UNITED STATES PATENT AND TRADEMARK OFFICE

| APPLICATION NO.          | FILING DATE | FIRST NAMED INVENTOR | ATTORNEY DOCKET NO.     | CONFIRMATION NO. |
|--------------------------|-------------|----------------------|-------------------------|------------------|
| 10/710,846               | 08/06/2004  | Eckhard Napp         | EP0209445               | 4845             |

| <b>Office Action Summary</b> | Application No.     | Applicant(s)  |

wherein the first profile and the second profile in the joined state define a cutout **A,B** (Figure 5 reprinted below with annotations) bridging the partition line and extending on both sides of the partition line;

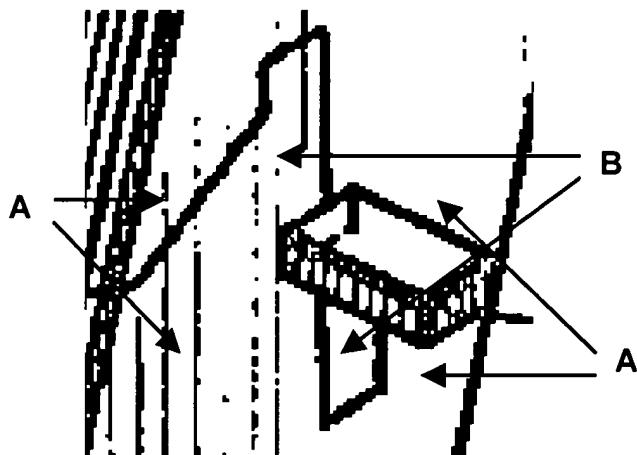
As to claim 1, Swanson discloses a connecting device for a first rod **55** and a second rod **55** to be connected to one another, the connecting device comprising:

a separate locking bar **34** having a cross-sectional shape matching a cross-section of the cutout;

three components of the unit in a locking direction opposite to the direction of the predetermined degree of freedom immediately before reaching the connecting position (Figure 5).

As to claim 2, Swanson discloses a connecting device wherein the first and second profiles each have an undercut **A** and wherein the first and second profiles engage one another in the connecting position by mutually engaging the undercut (Figure 5).

As to claim 3, Swanson discloses a connecting device wherein the first and second profiles each have an undercut **B** and wherein the locking bar **34** engages the undercut of the first and second profiles (Figure 5).

As to claim 4, Swanson discloses a connecting device wherein the first and second profiles each have a first undercut **A** and a second undercut **B**, wherein the first and second profiles engage one another by mutually engaging the first undercut, and wherein the locking bar **34** engages the second undercut, respectively (Figure 5).

As to claim 5, Swanson discloses a connecting device wherein a longitudinal axis of the locking bar **34** extends perpendicularly to the direction of the predetermined degree of freedom (Figure 5).

As to claim 6, Swanson discloses a connecting device wherein a longitudinal axis of the locking bar extends at a slant (angle) to the direction of the predetermined degree of freedom (Figure 5).

As to claim 7, Swanson discloses a connecting device wherein the first and second rods **55** are joined at an acute angle, an obtuse angle or a right angle relative to one another (Figure 5).

As to claim 8, Swanson discloses a connecting device wherein four (not shown) of the first and second rods **34** are joined to form a frame (Figure 5).

As to claim 9, Swanson discloses a connecting device wherein the locking bar **34** is removable from the cutout **B** (Figure 5).

As to claim 10, Swanson discloses a connecting device wherein the locking bar **34** is non-releasable (locked in position due to friction-fit) once inserted into the cutout **B** (Figure 5).

As to claim 11, Swanson discloses a connecting device wherein the locking bar **34** has a cross-section selected from the group consisting of a rectangular shape, a circular shape, a diamond shape, a figure eight shape, a dovetail shape, an elliptical shape, and a cross shape (Figure 5).

As to claim 14, Swanson discloses a connecting device wherein the first and second profiles in the joined state have rotation symmetry (Figure 5).
